MAINE YANKEE ATOMIC POWER COMPANY
ENGINEERING OFFICE

B3.2.1
WMY 79- 98
September 20, 1979

Subject: Submittal of Additional Information on Fire Protection Items

SER Section 3.2.1, Safe Shutdown Capability

MACHINE LOCATION PLAN
SERVICE BUILDING SH-1
 ATOMIC POWER STATION
MAINE YANKEE ATOMIC POWER COMPANY
 WISCASSET, MAINE
 STONE & WEBSTER ENGINEERING CORPORATION
 BOSTON, MAINE
 DRAWING NUMBER **11550-FM-3K**

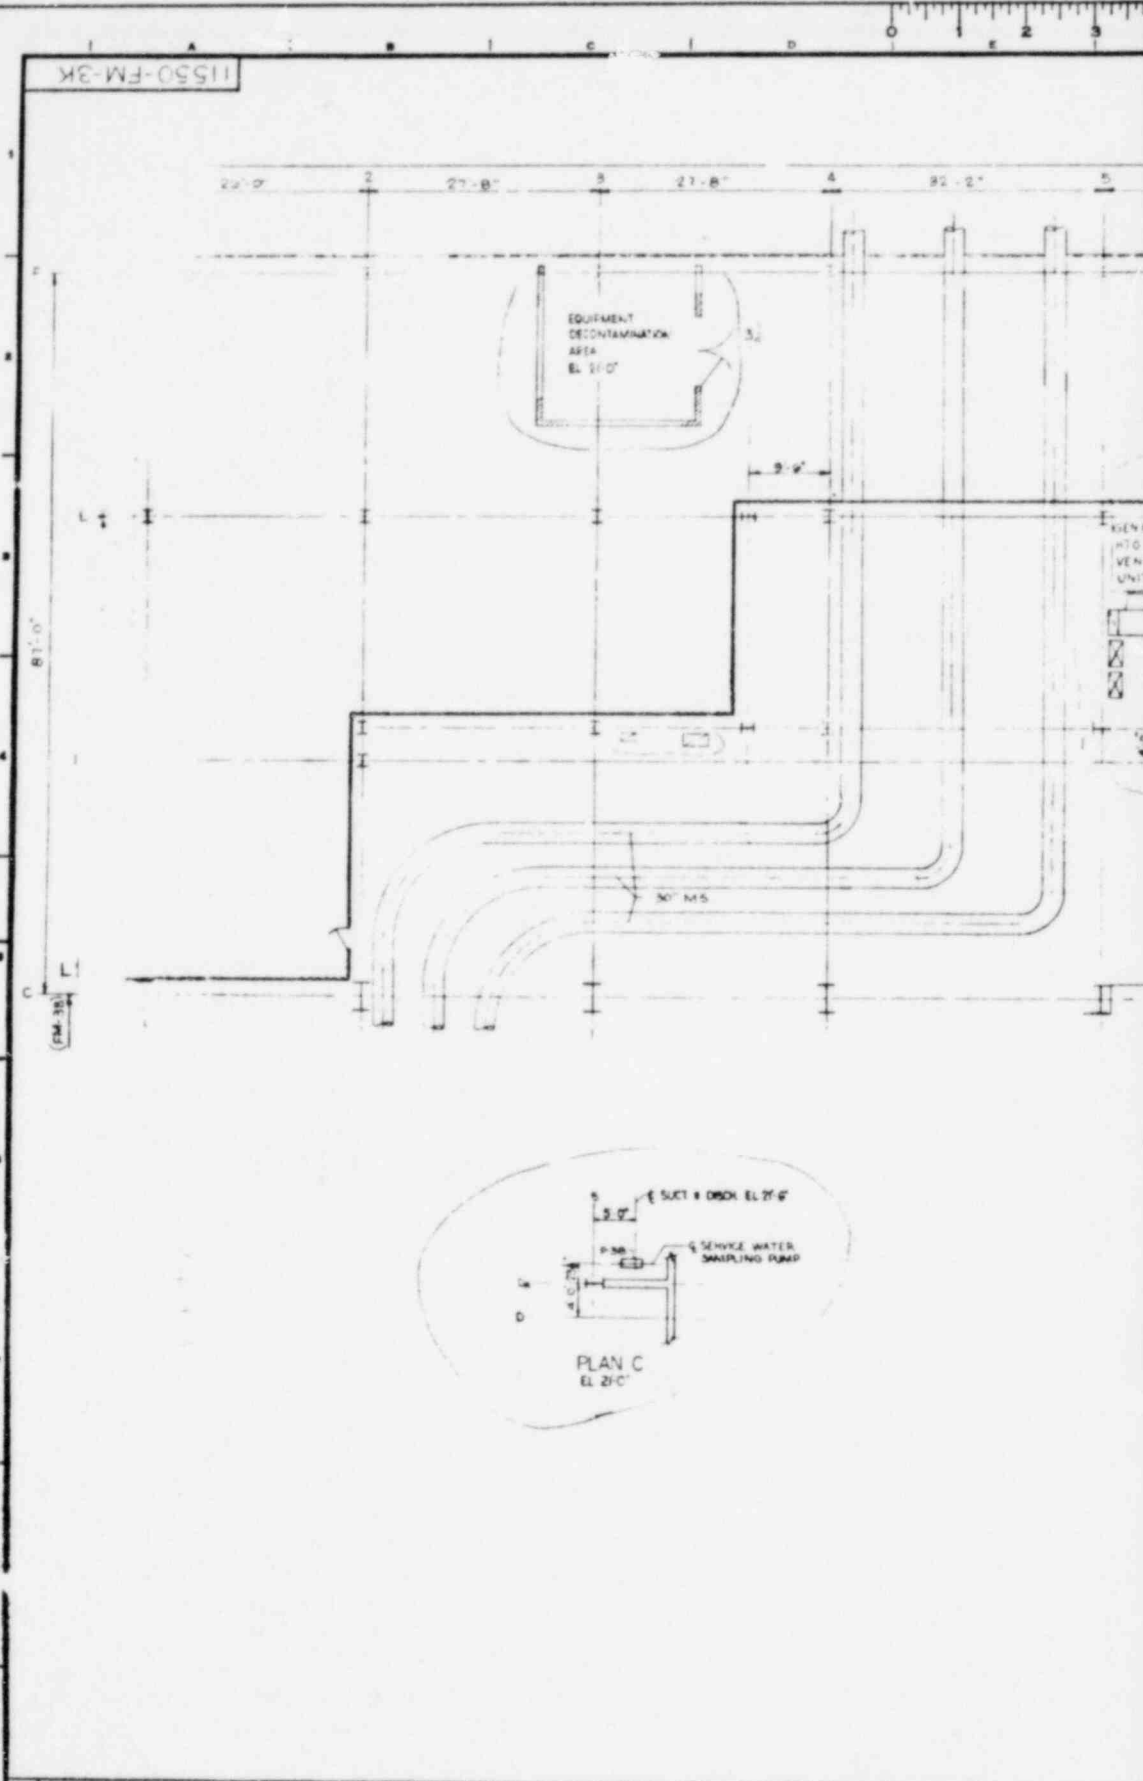
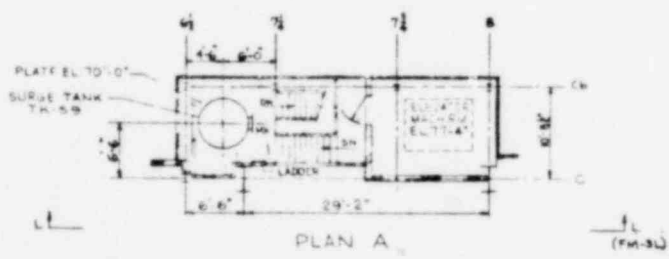
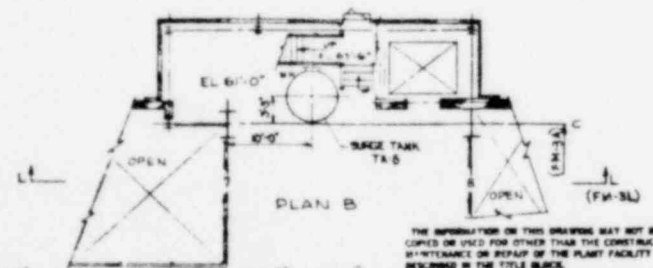
Boration and primary system make-up is normally achieved with the use of one (1) of three (3) main charging pumps or as an alternative with the auxiliary charging pump. The power supply cables to the motors for all four of these pumps originally passed through the same fire areas. Therefore, the power supply cables to the motor for the auxiliary charging pump were rerouted to avoid, to the extent possible, the areas through which the power supply cables to the motors for the main charging pumps were routed. The routing for the power supply cables for both the main and auxiliary charging pump motors, as it now exists, is shown on the attached drawings FM-2A and 3K.

The electrical distribution system at Maine Yankee is such that the 480 volt power comes from 4160/480 volt transformers. As indicated on FM-3K the 4160 volt power feeder to the 480 volt switchgear for the auxiliary charging pump is routed through the Protected Cable Tray Room, as are the 4160 volt power cables to the main charging pumps. At the points of entry into the room, they are separated by 15 feet and run in opposite directions. The power feeder for the auxiliary charging pump is then routed in a cable tray which ultimately travels along the north wall of the Protected Cable Tray Room into the unprotected cable tray room through a 3-hour fire wall. The power cables to the main charging pumps are routed through trays adjacent to the south wall of the Protected Cable Tray Room. The north and south walls of the Protected Cable Tray Room are separated by a distance of 60 feet. As is noted in Section 5.6 of the Fire Protection SER, the combustibles in the area consist of moderate amounts of plastic and rubber cable insulation. The trays connecting the north end and south ends of the room contain very little cable; and much of it is armored 4160 volt cable. The SER section lists many modifications to, and improvements in the fire protection systems available in the room. These modifications, the ease of access to the room and the 60 feet of spatial separation which exist makes it unlikely that a fire would incapacitate the three main charging pumps as well as the auxiliary charging pump. Therefore, Maine Yankee feels that a charging pump will always be available for boration and makeup.

From the unprotected cable tray room the 4160 volt power feeder for the auxiliary charging pump is run up to the 4160/480 volt transformers in the unprotected switchgear room. From the 480 volt switchgear in this room, a 480 volt power feeder cable is run back down into the unprotected cable tray room and finally into the Primary Auxiliary Building through the wall between these two areas. In contrast the power supply cables to the main charging pump motors originate from the 4160 volt switchgear in the protected switchgear room. The routing for these cables is through the Protected Cable Tray Room, Control Room Cable Chase and Protected Cable Vault before entering the Primary Auxiliary Building. The power cables for the auxiliary and main charging pump motors originate from and are routed to the Primary Auxiliary Building through different areas and are completely separated by one or more three (3) hour fire rated barriers.

ARRGT-PRIMARY AUX BLDG-SH-1
 ATOMIC POWER STATION
 MAINE YANKEE ATOMIC POWER COMPANY
 WISCASSET, MAINE
 STONE & WEBSTER ENGINEERING CORPORATION
 BOSTON, MASS.
 NUMBER 11550-FM-2A

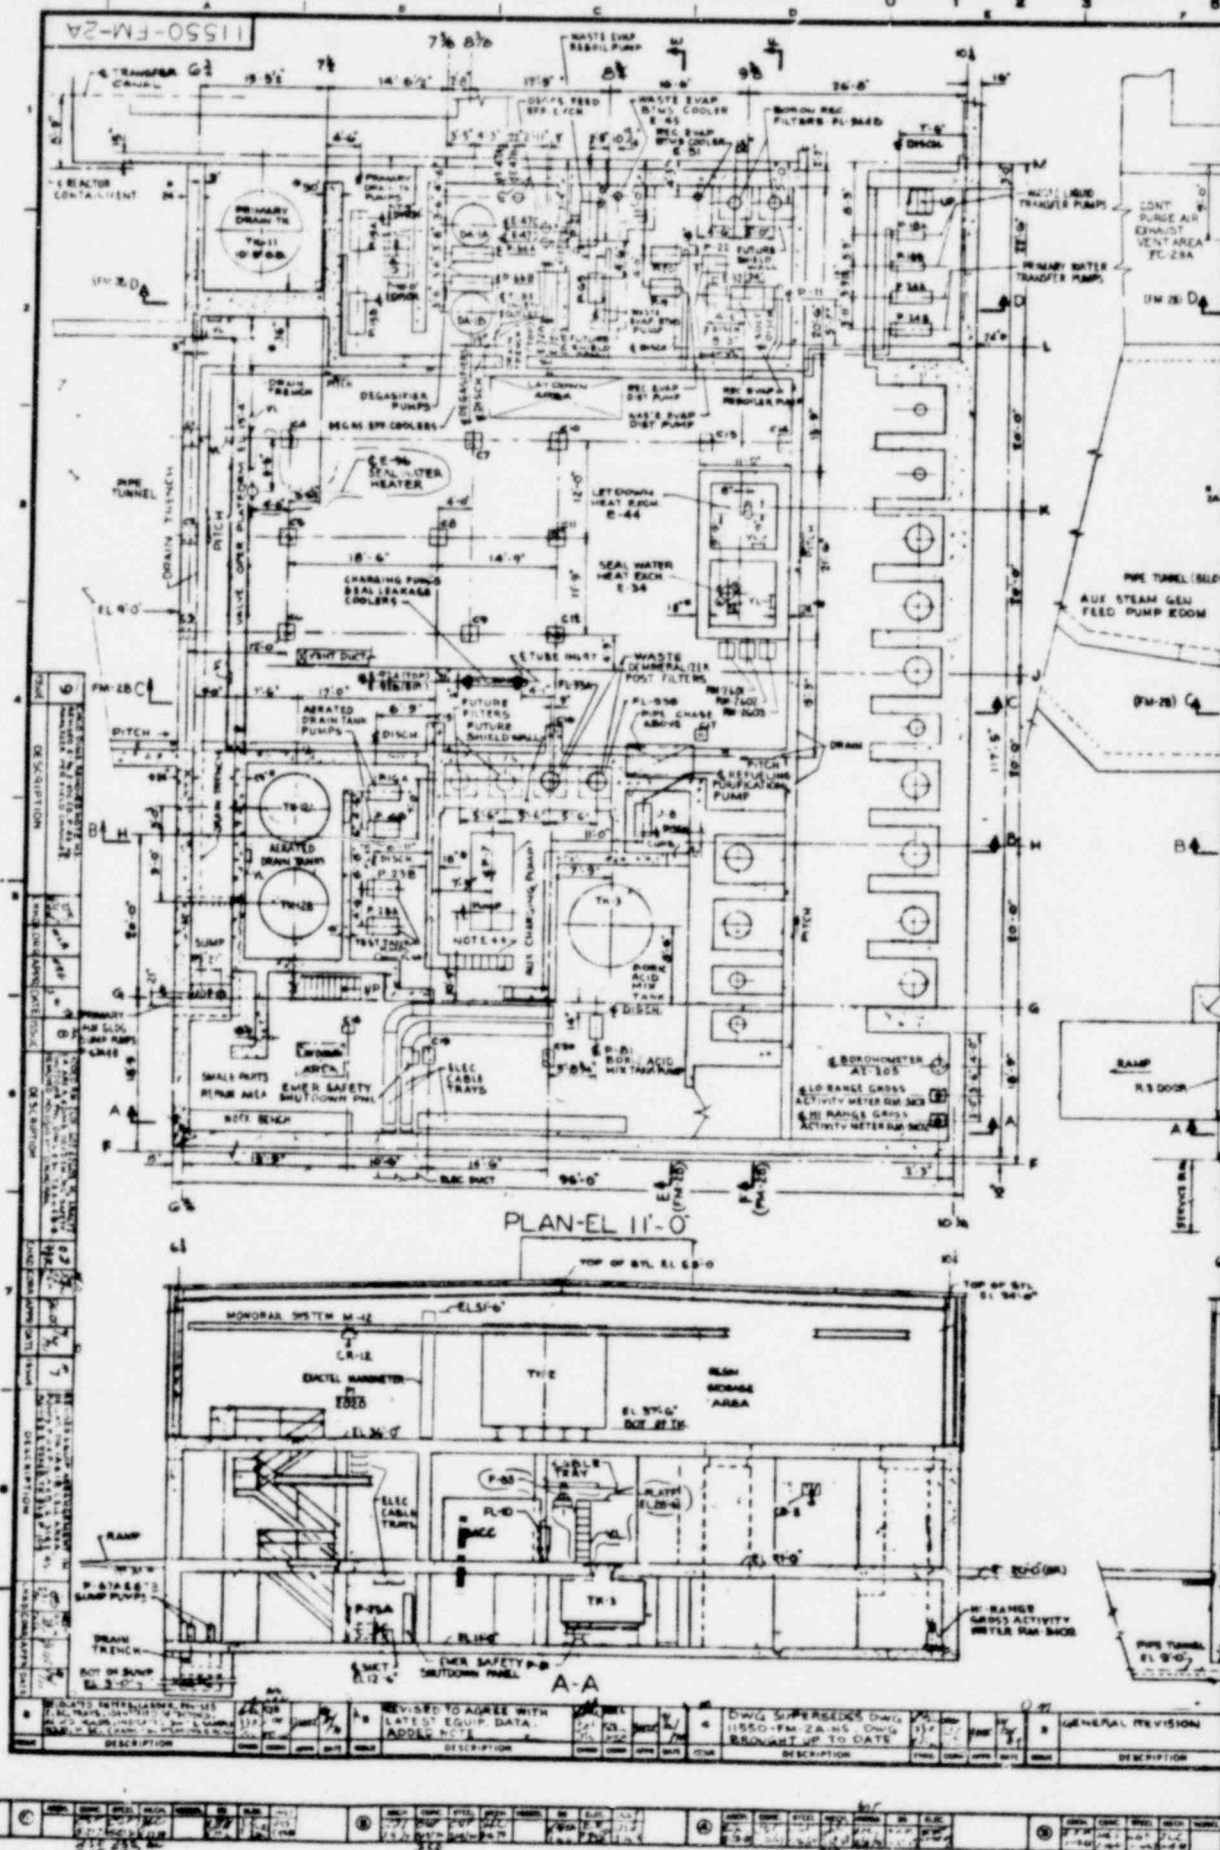
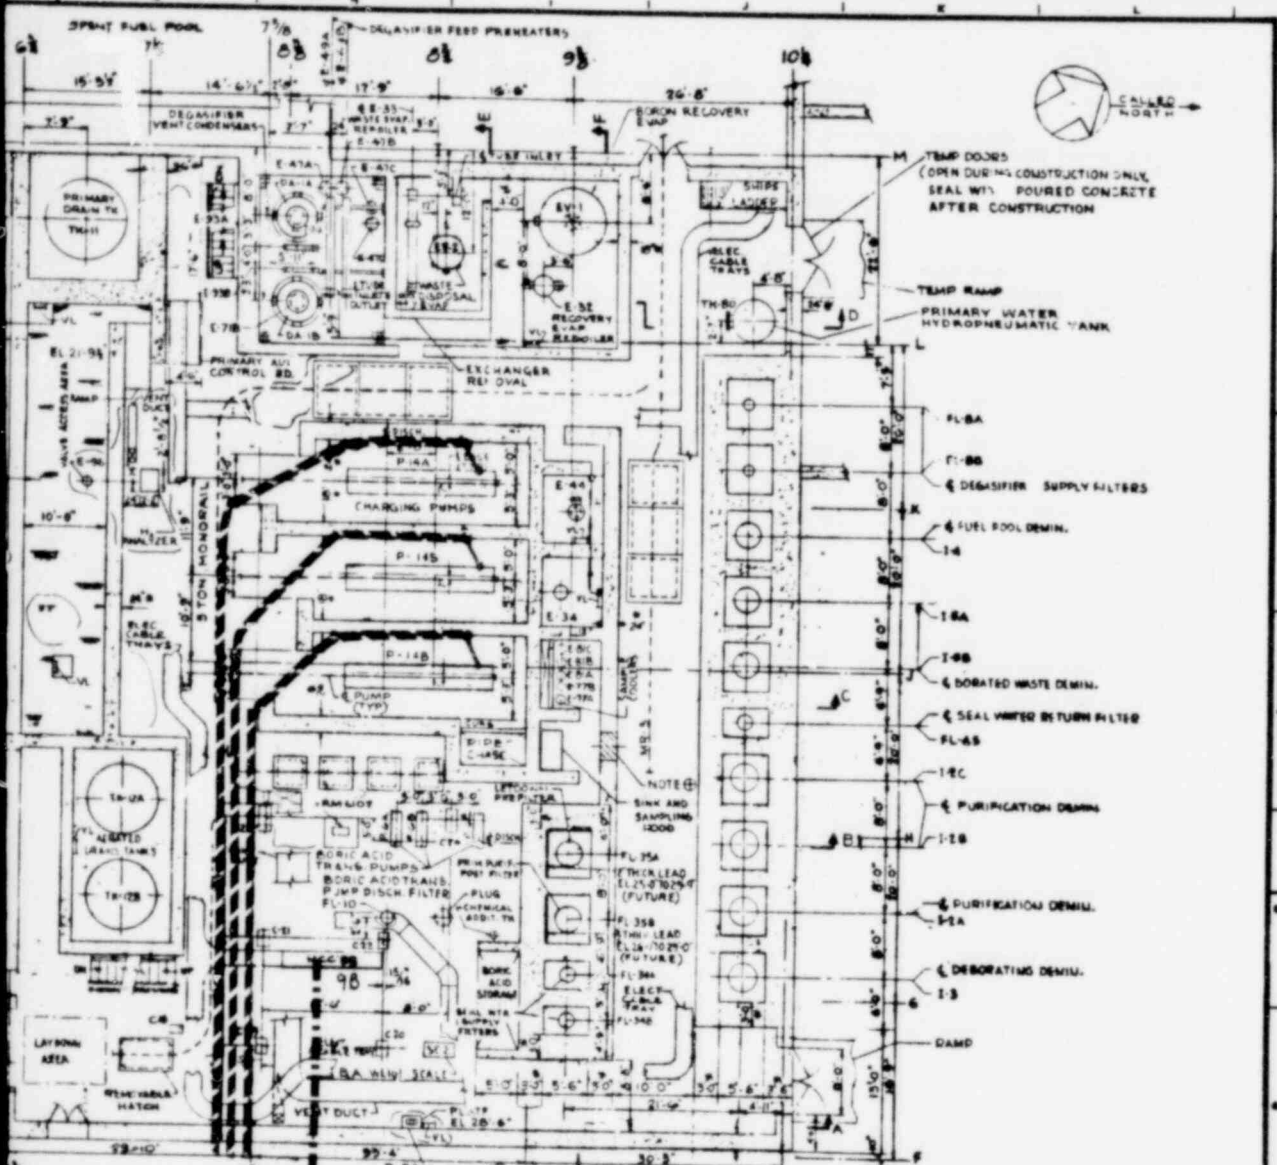
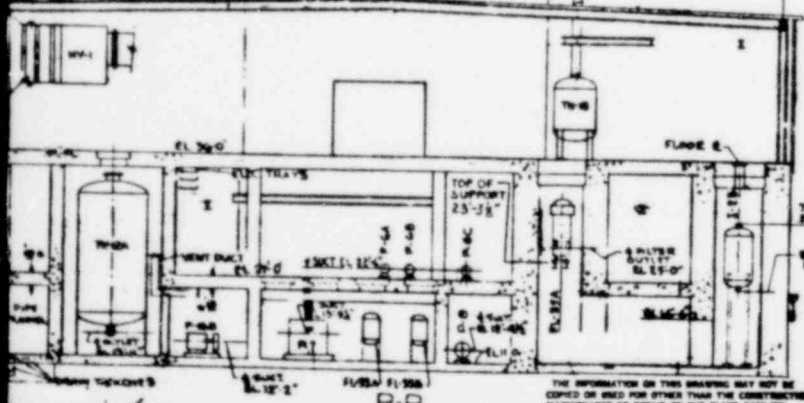
The power feeder cable for the auxiliary charging pump after entering the Primary Auxiliary Building is routed in a generally downward direction to MCC-9B. Specifically, the feeder penetrates the Primary Auxiliary Building in sleeves through the east wall above the 36 foot floor elevation. From here it enters a vertical riser adjacent to the wall and is routed down to just below the ceiling of the 21 foot floor elevation. From this point, the feeder is run in conduit to MCC-9B and enters from the top. The motor leads for the auxiliary charging pump exit MCC-9B from the bottom and are run in conduit directly to the pump located on the 11 foot floor elevation.

In contrast after entering the Primary Auxiliary Building directly from the Protected Cable Vault, the power supply cables to the main charging pump motors are routed through separate, four (4) inch conduit embedded in the concrete floor of the 21 foot floor elevation in the Primary Auxiliary Building. Because these power supply cables are routed in conduit embedded in concrete, it is not credible that they would be damaged by a fire which disabled either MCC-9B or the power feeder to this MCC for the auxiliary charging pump.
